CitiPower/Powercor Technical Standards Update for April 2021

Release date: 12 May 2021

EF981-998 Series – HV live line clamp bridge assembly rod Key changes* Release date: 12 May 2021

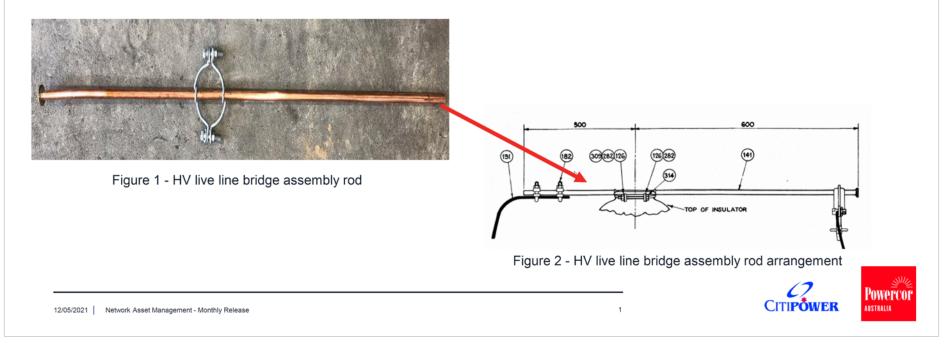
- Technical Standard EF985 has been created to include the HV live line bridge assembly rod (see figure 1 below).
- The rod is to be used for maintenance purposes only of existing arrangements where this type of bridge assembly rod is installed. These rods may be found on SECV era structures (see figure 2 below).

Feedback from the Maryborough Depot advised that the material was approved and available within the SAP material system and depot stores but was not documented in the Technical Standards.
